PIC16C923 Rev. A Silicon/Data Sheet Errata

The PIC16C923 (Rev. A) parts you have received conform functionally to the Device Data Sheet (DS30444E), except for the anomalies described below.

FIGURE 1: SCK PULSE VARIATION USING TIMER 2/2

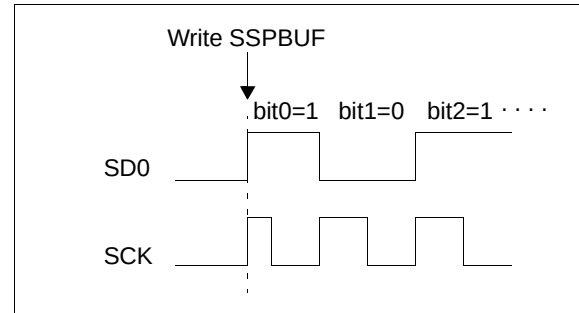
When the SPI is using Timer2/2 as the clock source, a shorter-than-expected SCK pulse may occur on the first bit of the transmitted/received data (see Figure 1).

To avoid producing the short pulse, turn off Timer2 and clear the TMR2 register, load the SSPBUF with the data to transmit, and then turn Timer2 back on. Refer to Example 2 for sample code.

FIGURE 1: WRITES TO TIMER1 (EXTERNAL CLOCK/OSCILLATOR MODE)

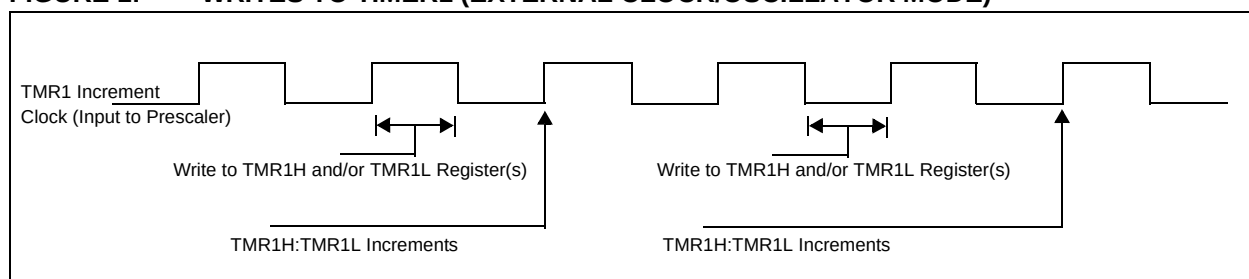
The operation of Timer1 needs some clarification when the timer registers are written and the TMR1ON bit is set.

The internal clock signal that is the input to the TMR1 prescaler affects the incrementing of Timer1 (TMR1H:TMR1L registers and the Timer1 prescaler). When the Timer1 registers are NOT written, the Timer1 will increment on the rising edge of the TMR1 increment clock.

When the TMR1H and/or TMR1L registers are written while this clock is high, TMR1 will increment on the next rising edge of this clock.

When the TMR1H and/or TMR1L registers are written while this clock is low, TMR1 will not increment on the next rising edge of this clock, but must first have a falling clock and then the rising clock for TMR1 to increment.

Figure 1 shows the two cases of writes to the TMR1H and/or TMR1L registers. Due to the V_{IH} and V_{IL} thresholds on the oscillator/clock pins, external Timer1 oscillator components, and external clock frequency, the Timer1 increment clock may not be of a 50% duty cycle.

FIGURE 2: PORTC BLOCK DIAGRAM (PERIPHERAL OUTPUT OVERRIDE)

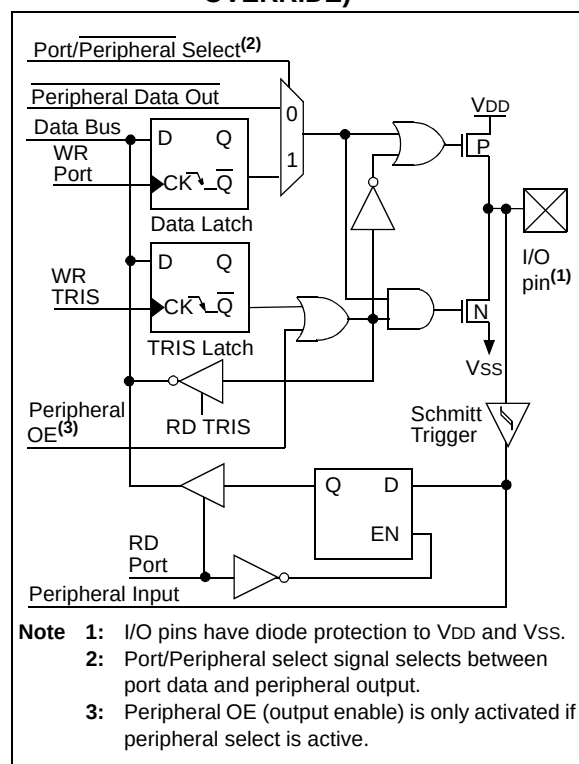
The block diagram for PORTC presented in Figure 5-5 of the Device Data Sheet (DS30444E) is incorrect. The correct block diagram is shown in Figure 2.

FIGURE 3: WAVEFORMS IN 1/2 MUX, 1/3 BIAS DRIVE

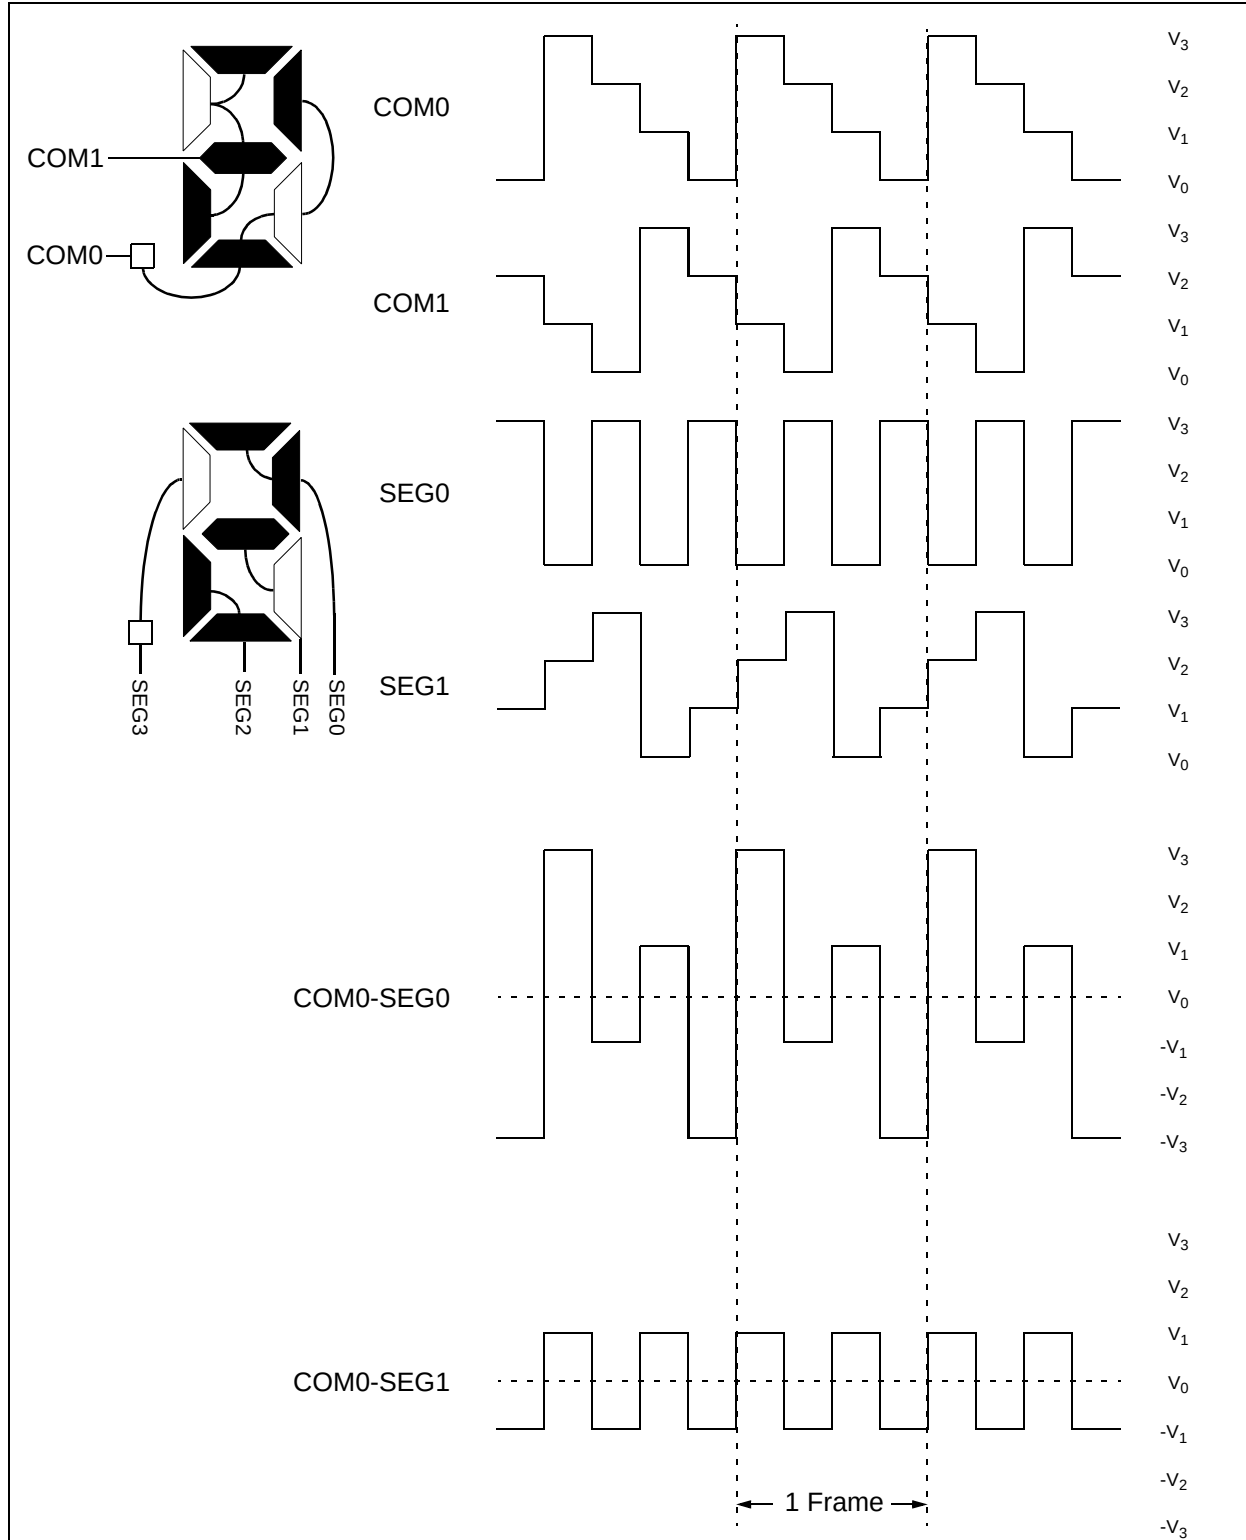
Figure 13-5 in the data sheet, depicting drive waveforms in 1/2 multiplex, 1/3 bias mode, is incorrect. Specifically, the connections for the

different LCD segments (SEG0 through SEG4) and the SEG1 drive waveform have been changed. The correct diagrams and waveforms are shown in Figure 3.
